Nacogdoches Historic Landmark Preservation Committee

Wednesday, September 13, 2023 at 4:00 PM

Historic Landmark Preservation Committee Meeting

ITEM/SUBJECT: Consider Certificate of Appropriateness for property located at 318 East Main Street. COA #2023-019

Sketch:

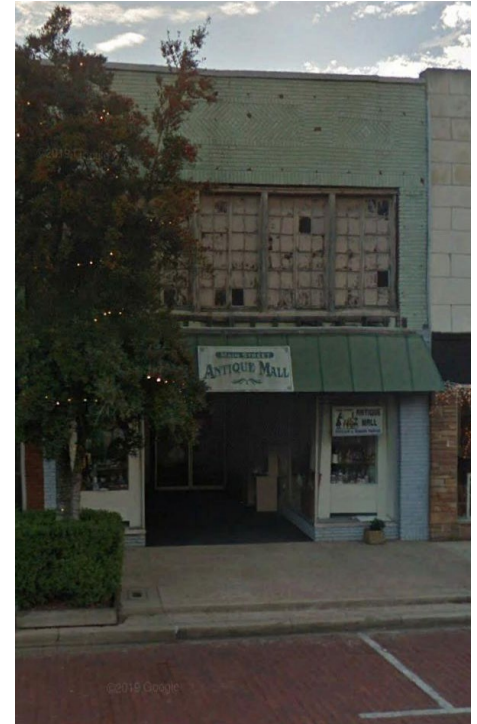
Per the design request submitted and sketch provided by the owner, shown on the right, the owner would like to replicate all architectural elements present on the 422 East Main Street facade to the 318 East Main Street property. While duplicating the same aesthetic is desired, it is important that all proposed alterations for the property at 318 E Main Street comply with the City of Nacogdoches' Code of Ordinances, Division 5 Certificate of Appropriateness, [Section 50-157 - Criteria for approval](#).

When comparing both properties, they significantly differ in overall proportion, scale, materials, and stylistic features. In addition to the differences aesthetically, there is no physical evidence or supporting historical documentation available that justifies the removal and replacement of the existing elements with conjectural features from another property.

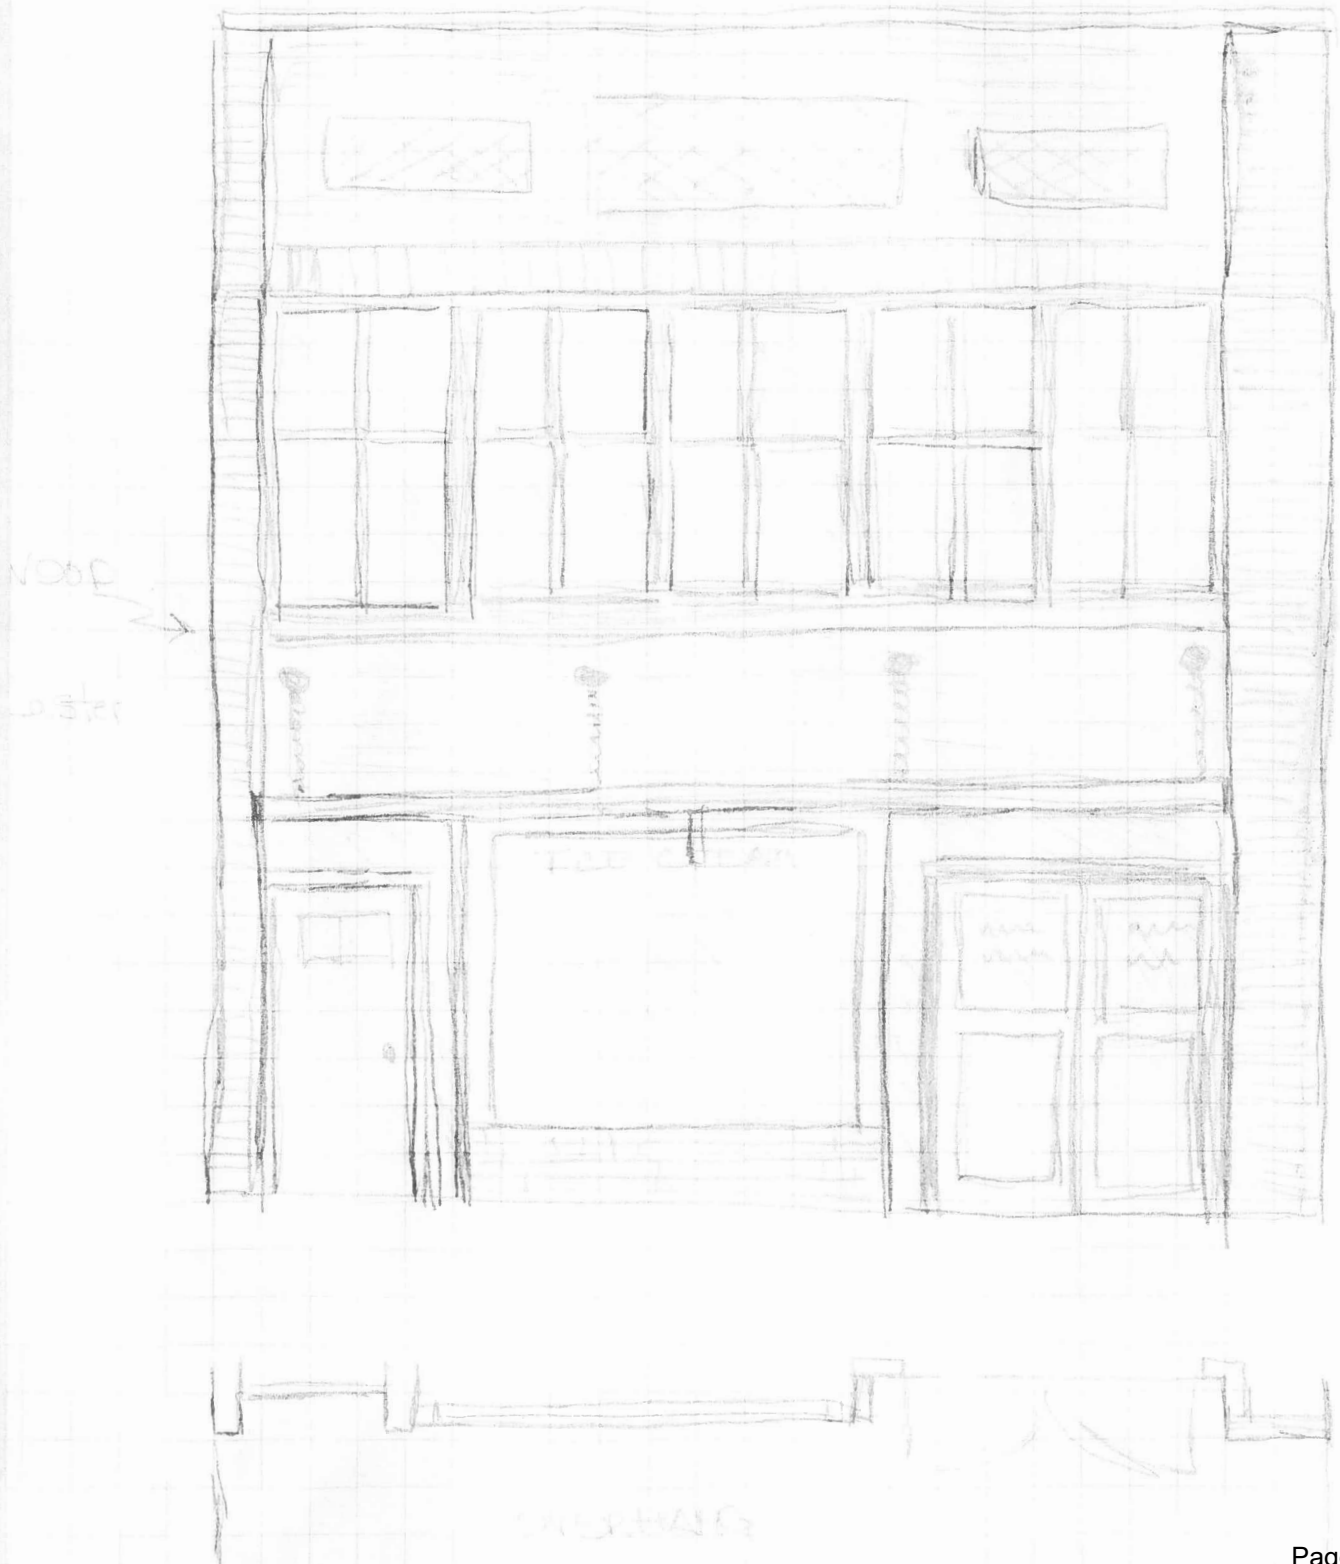
The applicant is essentially requesting approval for the top half of Design A (attached) and the bottom half of Design B (attached).

The applicant worked with a local designer to come up with an alternate front facade design which is being presented today. The designs are a blend of the 422 East Main Facade and elements of the Texas Historical Commission's designs.
